**SUNDRY NOTICES AND REPORTS ON WELLS**  
*Do not use this form for proposals to drill or to re-enter an abandoned well. Use form 3160-3 (APD) for such proposals.*

1. Type of Well <input type="checkbox"/> Oil Well <input checked="" type="checkbox"/> Gas Well <input type="checkbox"/> Other		8. Well Name and No. HURON 1A
2. Name of Operator HILCORP ENERGY COMPANY		9. API Well No. 30-039-21511-00-S1
3a. Address 382 ROAD 3100 AZTEC, NM 87410		10. Field and Pool or Exploratory Area BLANCO
3b. Phone No. (include area code) Ph: 505-324-5161		11. County or Parish, State RIO ARRIBA COUNTY, NM
4. Location of Well (Footage, Sec., T., R., M., or Survey Description) Sec 2 T26N R4W SWNW 1850FNL 0790FWL

Hilcorp Energy requests permission to P&A the subject well per the attached procedure, current and proposed wellbore schematics and reclamation plan - Preonsite inspection conducted 9/17/20 with Bob Switzer (BLM).

Re: Permanent Abandonment  
Well: Huron 1a  
(API# 30-039-21511)

## HURON 1A - PROPOSED WELLBORE SCHEMATIC

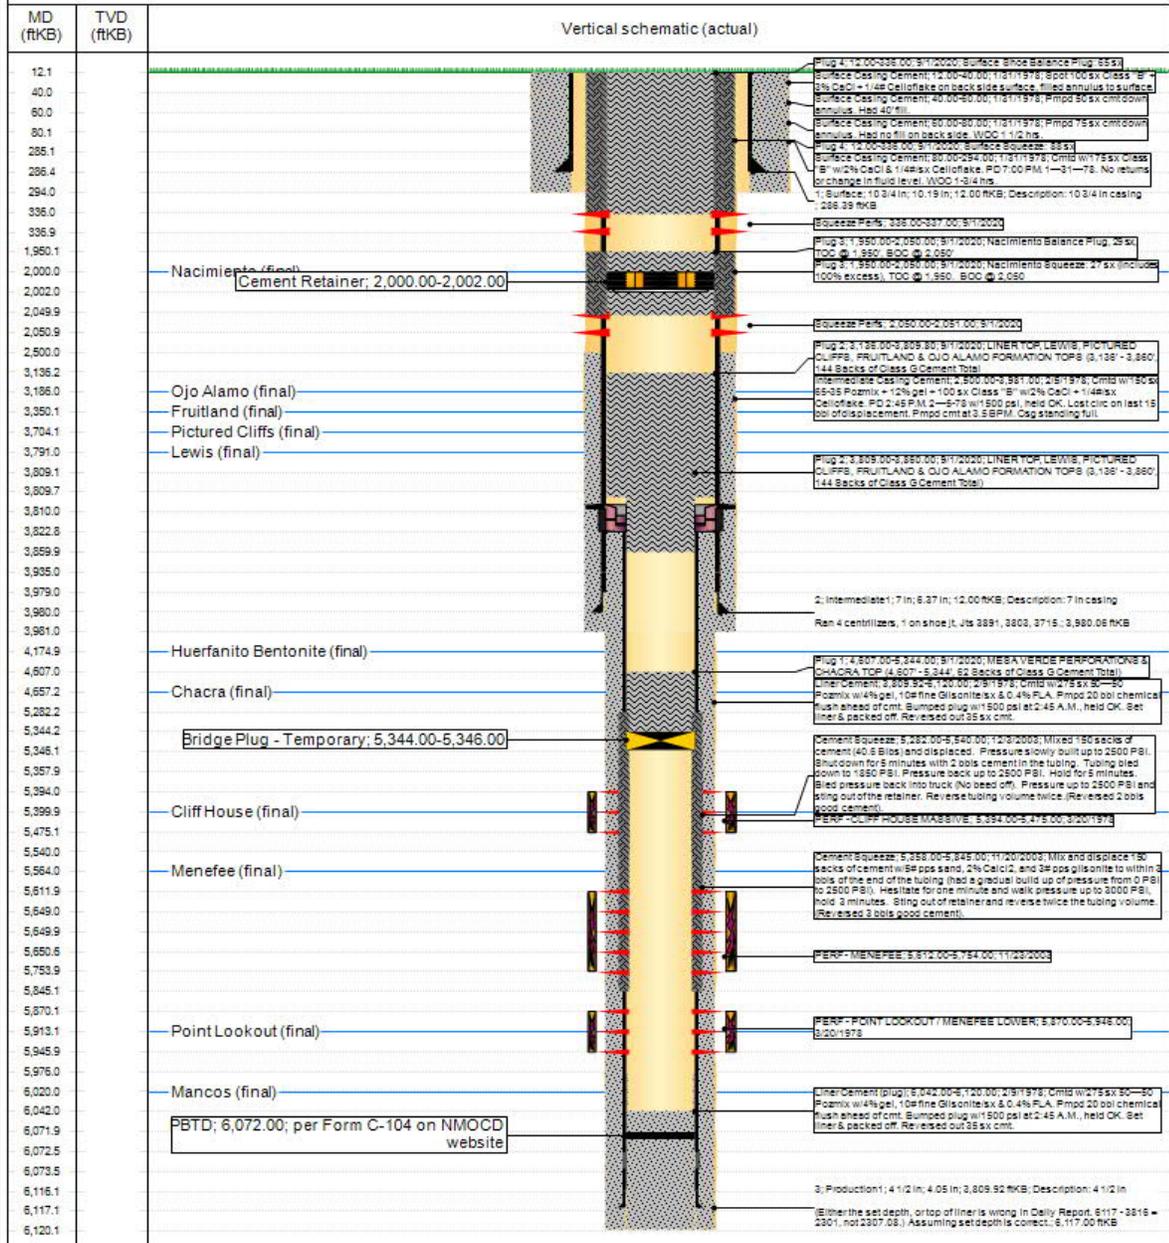
1. Plugging operations authorized are subject to the attached "General Requirements for Permanent Abandonment of Wells on Federal and Indian Lease."
2. Farmington Office is to be notified at least 24 hours before the plugging operations commence (505) 564-7750.
3. BLM picks Nacimiento at 2008' md (see geologic report). Adjust plug 3 to provide coverage 2058' to 1958'.
